AMEC GEOTECHNICAL INSPECTION REPORT TO P-LAKE SEWAGE LAGOON, 2008

October 24, 2008

**Re: Sewage Lagoon Berm Inspection
Cape Dorset, NU**

Photograph 1: First water entry area located about 100 to 120 m

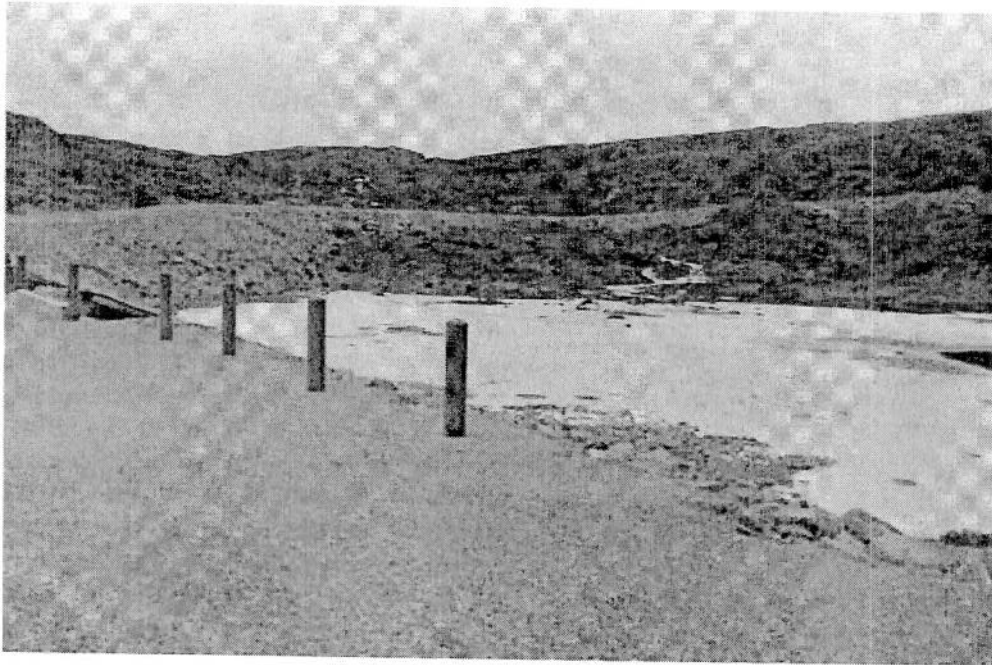
Run-off water seeping through the road way embankment into the lagoon impoundment was identified in two locations along the south roadway connecting the main west berm to the smaller north berm. The first run-off seepage was located about 100 m to 120 m south from the smaller north berm, while the second run-off seepage location was located about 20 m to 40 m south of the main berm. At these locations, water freely seeps through the road embankment, consisting of sandy crushed rock with some fines. The inflow seepage originates as run-off water from the mountain slope which is situated immediately south of the roadway. Both seepage locations are shown on Figure 1, and Photographs 1 and 2, Appendix A.

The run-off water that seeps through the road embankment into the lagoon should be diverted away from the lagoon impoundment.

Photograph 3: Water exiting the large main berm

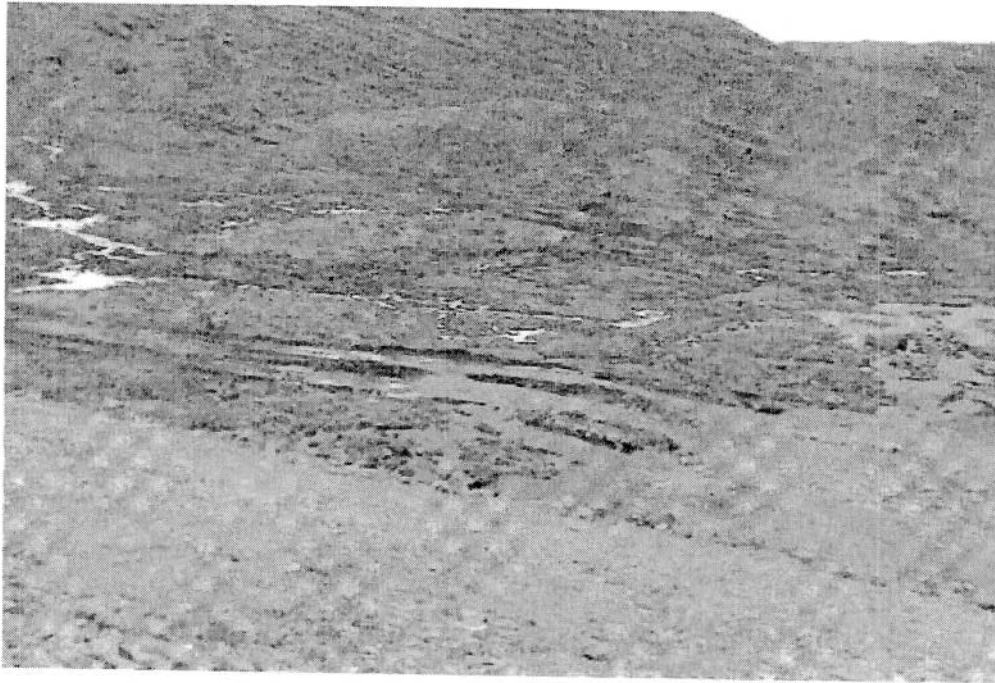
Water leaking from the lagoon impoundment was identified along the toe of the main berm, about 20 to 30 meters south of the emergency spillway (Photograph 3, Appendix A). It is believed that the water is leaking through or underneath the unfrozen larger main berm. It was demonstrated by the geothermal analysis, that at the end of the first summer, the majority of the berm and subgrade remain at temperature just below 0 °C. Thus, by allowing the run-off water to accumulate, premature thermal degradation began to occur within the berm allowing the water to leak under a considerable hydraulic gradient through the berm and around or through the liner. It is believed that the liner could be damaged (torn), or improperly sealed off within the cut-off trench.

No immediate actions are required to reduce the water leaking through the main berm. It is expected that a frozen core will be re-created within the berm after a second winter season (2008/2009) which will significantly reduce or eliminate the water seeping through the main berm.

It is recommended that snow be removed from the crest and sideslopes of the main berm, at least twice per month during 2008/2009 winter season.

Photograph 4: Water flowing through drainage pipe

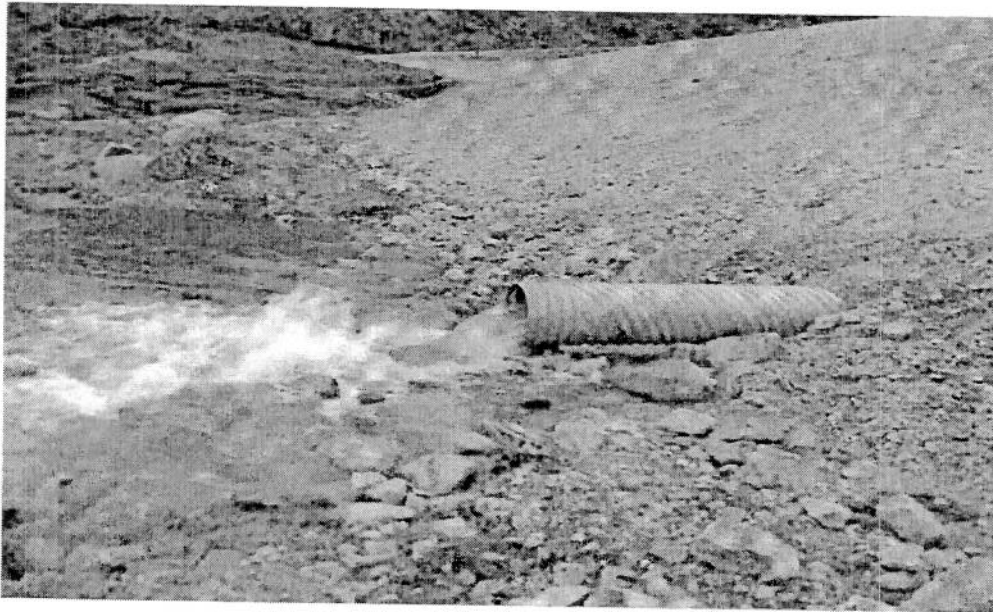
On September 30, 2008 at about 1:30 pm, the valve controlling the lagoon drainage pipe was re-opened allowing run-off water to drain into P-lake (Photograph 4, Appendix A). The water level near the area of the leak dropped down about 20 mm after 3 hours of water flowing through the drainage pipe (Photograph 5, Appendix A). On October 1, 2008, the water flow from the drainage pipe dropped considerably (Photograph 6, Appendix A).
